Docket No. 50-272

The Commission has issued the enclosed Amendment No. 1) to Facility Operating License No. DPR-70 for the Salem Nuclear Generating Station Unit No. 1 in response to your application dated August 1, 1977. The amendment revises the Technical Specifications and consists of addition of interim specifications on Fire Protection.

SALEM NUCLEAR GENERATING STATION, UNIT NO. 1

Amendment No. 11
License No. DPR-70

FIGURE 6.2-1. OFFSITE ORGANIZATION FOR FACILITY MANAGEMENT AND TECHNICAL SUPPORT

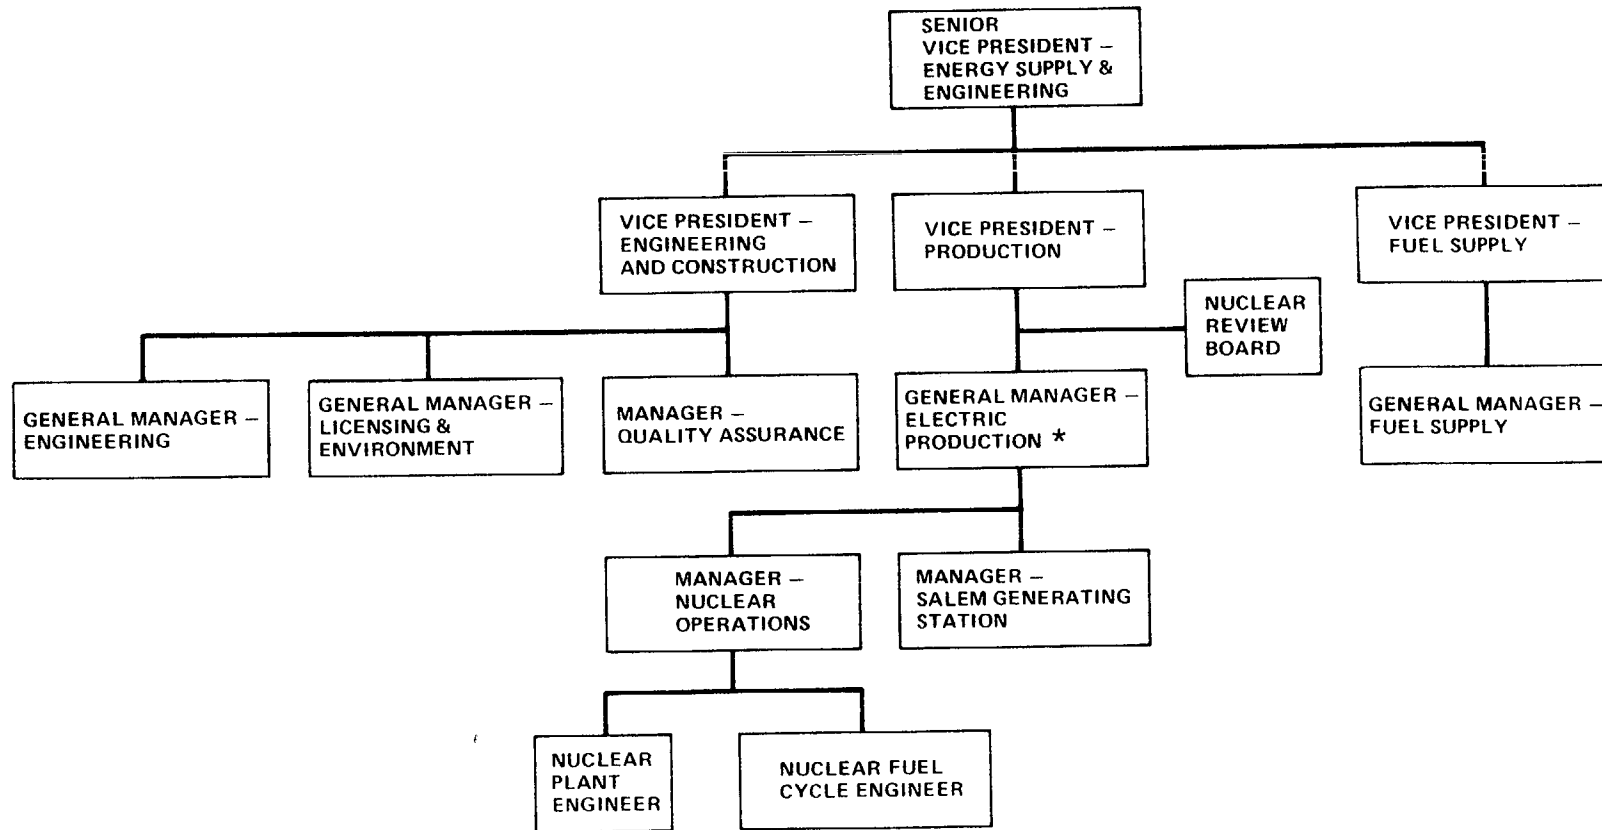
5. Figures 6.2-1 and 6.2-2

We recognize that these charts indicate organizational structure and that functional responsibilities are defined in the Fire Protection Program Manual. However, we require that specifications indicate at what level, corporate and station, fire protection responsibility is assigned. Accordingly, the amendment does not delete this indication.

* Responsible for overall Fire Protection Program
